CHANGE ORDER #~~32~~³¹

Project: Barfield Highway Reconstruction
Date of Issuance: 11/27/2023
Owner: City of Pahokee
Project Engineer: Momentum CEI
Consultant/Contractor: Rosso Site Development

Project No: FM# 442030-1-31-01
Effective Date: 10/9/2024

Barfield Highway Change Order #~~31~~³¹ – This change order is for Barfield Highway Reconstruction. The change order is to compensate Rosso Site Development (contractor) for plan revision #7.

Conflict Area

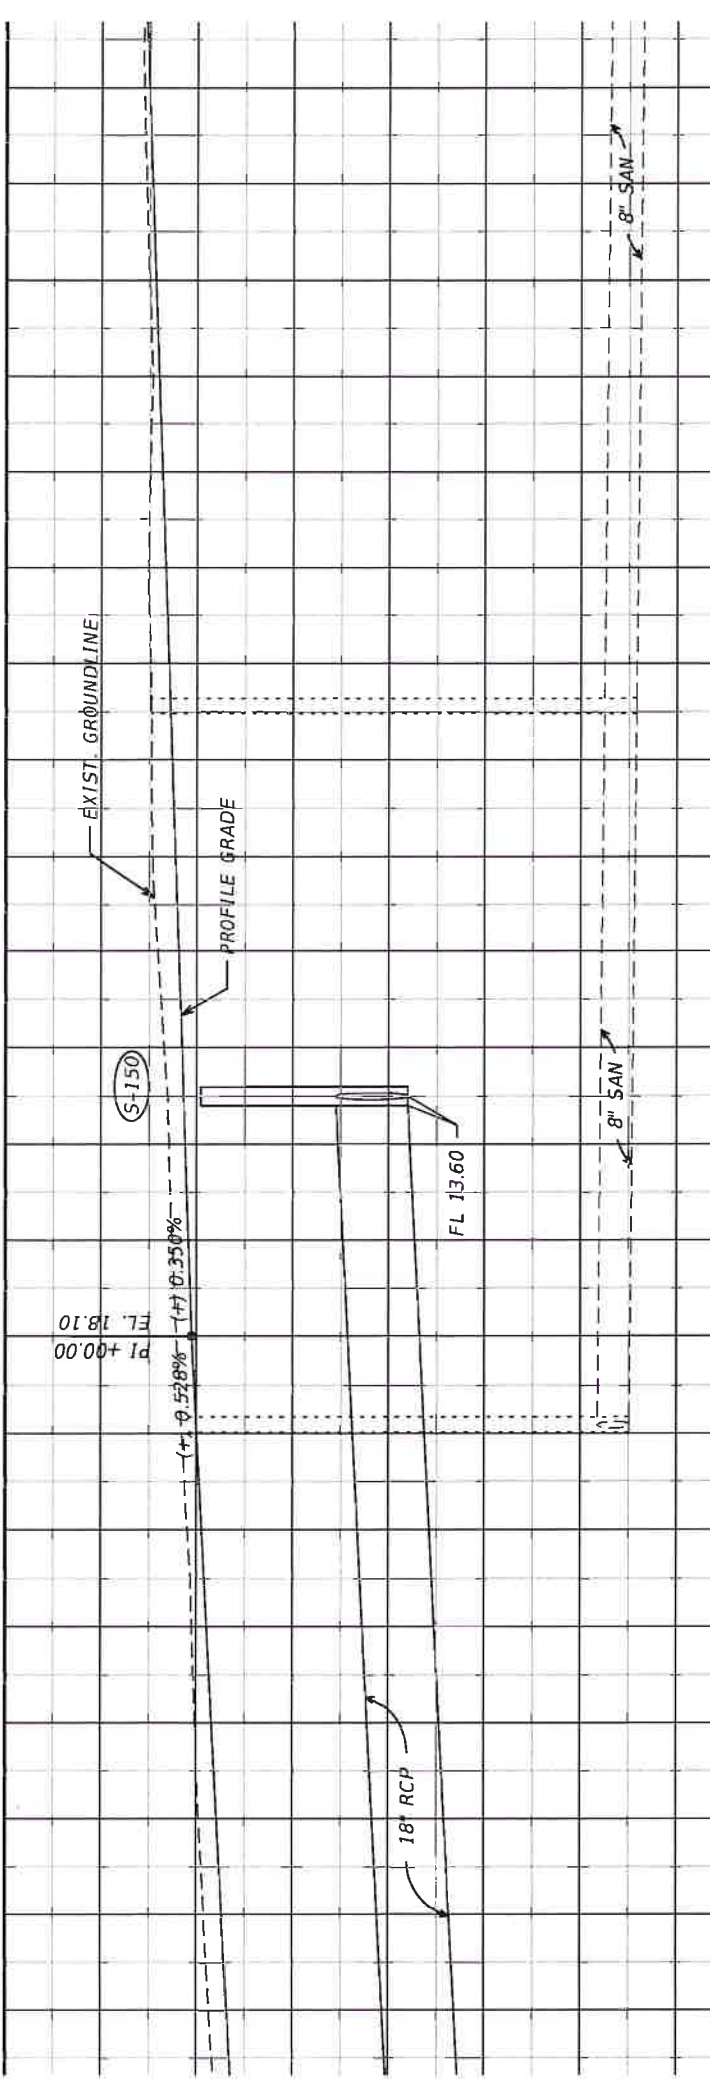
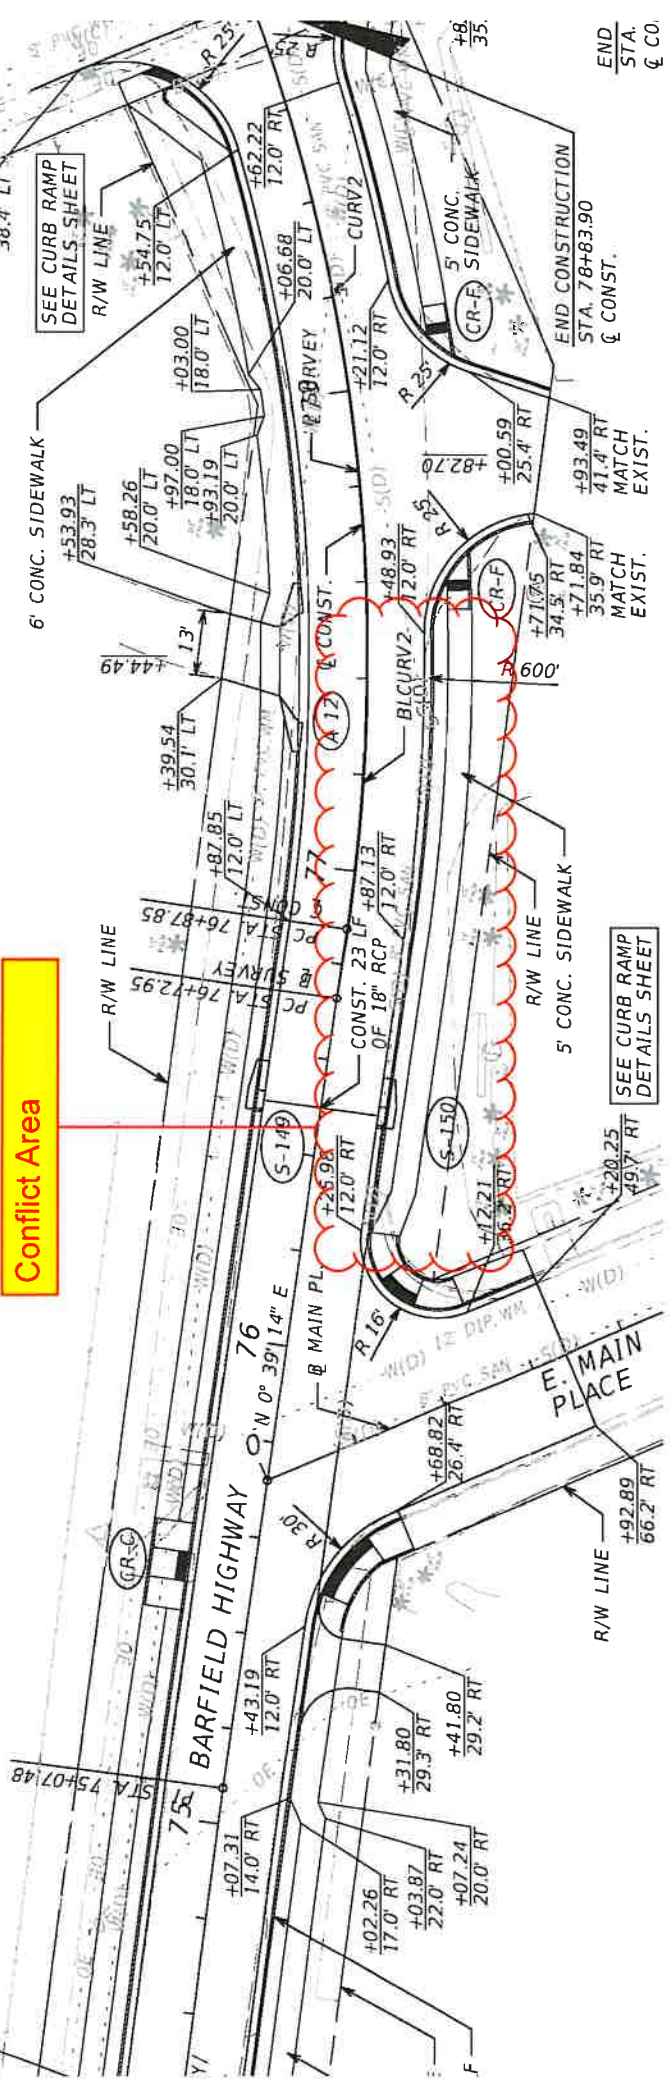
The existing sewer will be in conflict with Drainage S-50 at STA 75+60. Please inform contractor on how to proceed.

The existing sewer will be in conflict with Drainage Str. 50. how does Johnson Davis need to proceed.

There is no conflict with S-150 per plan sheet 22 elevation. There is a conflict with an existing sanitary sewer manhole at station 75+80 Rt. Use Attached revision #7 to go around the conflict.

Conflict Area

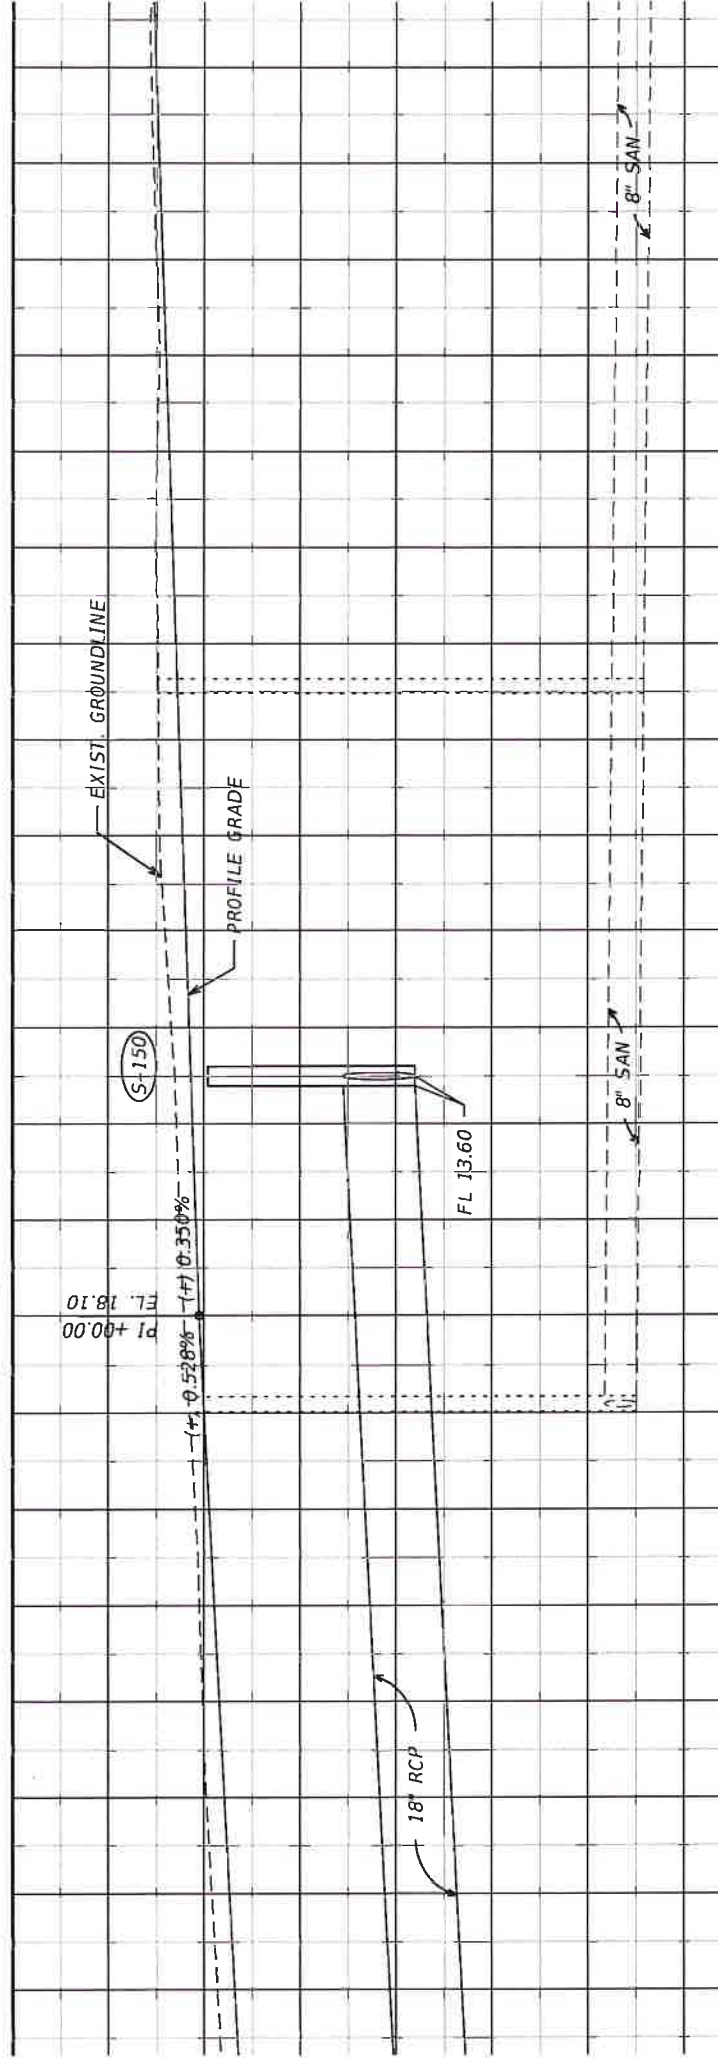
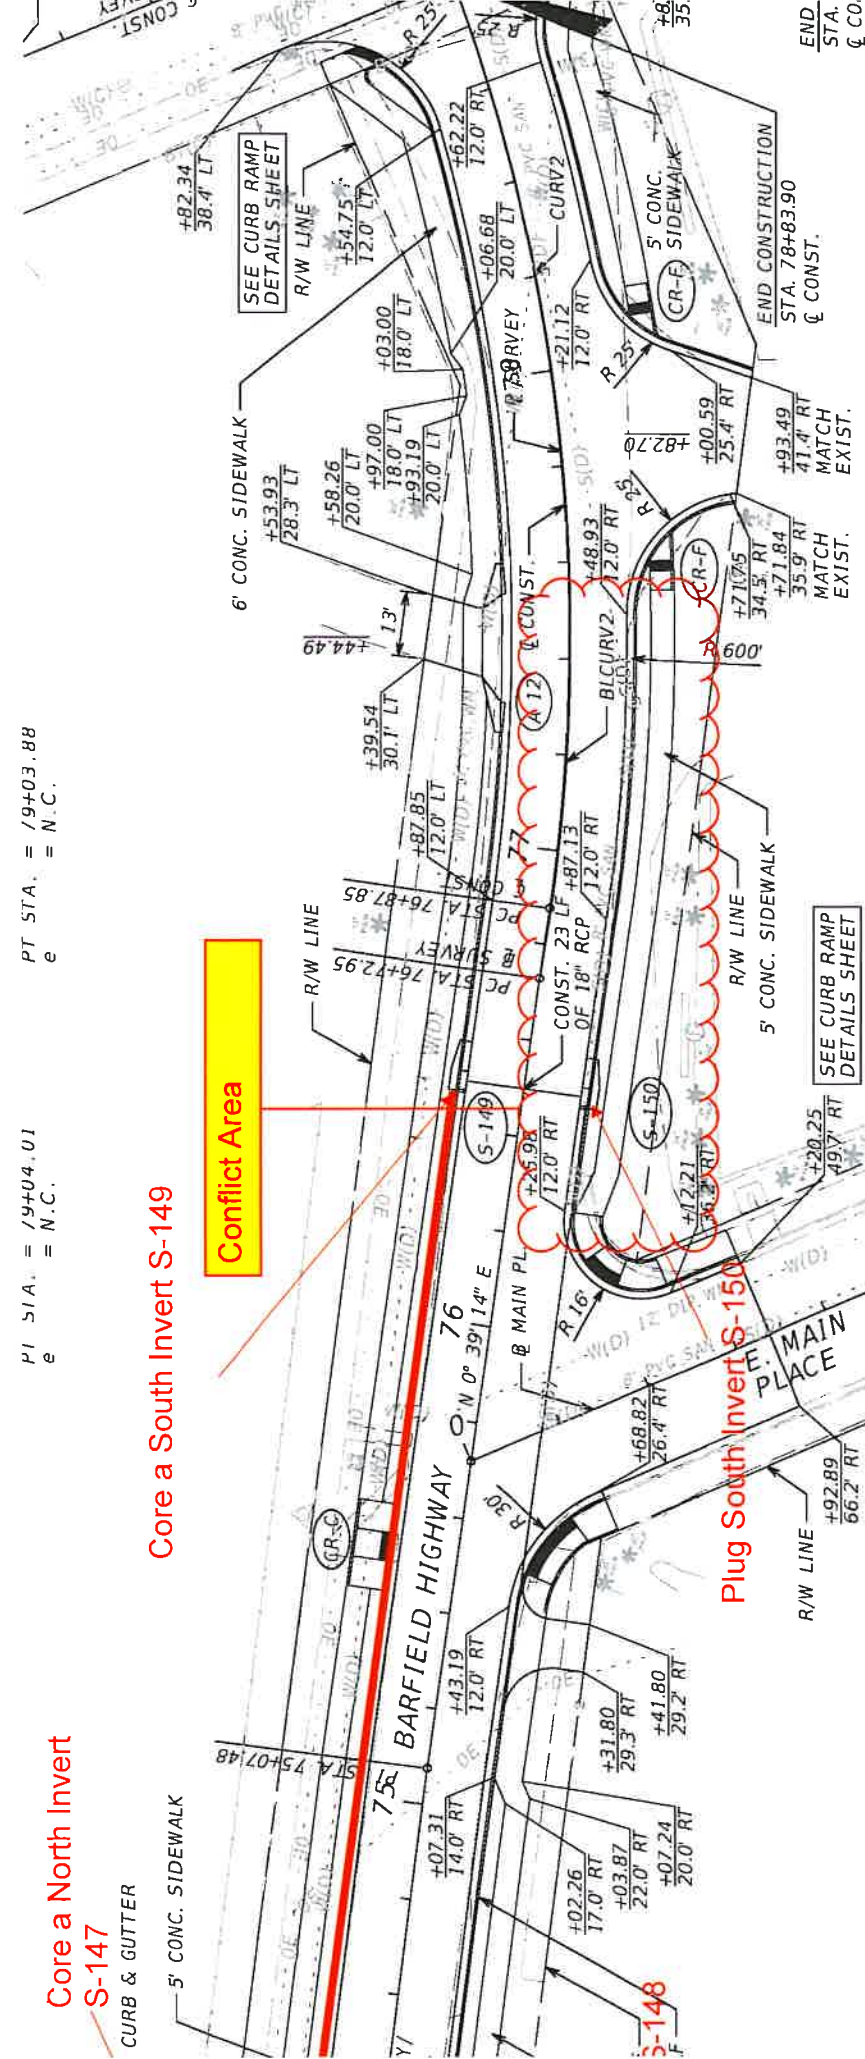
The existing sewer will be in conflict with Drainage S-50 at STA 75+60. Please inform contractor on how to proceed.

The existing sewer will be in conflict with Drainage Str. 50. how does Johnson Davis need to proceed.

Core a North Invert
S-147
CURB & GUTTER

Core a South Invert S-149

There is no conflict with S-150 per plan sheet 22 elevation. There is a conflict with an existing sanitary sewer manhole at station 75+80 Rt. Use Attached revision #7 to go around the conflict.
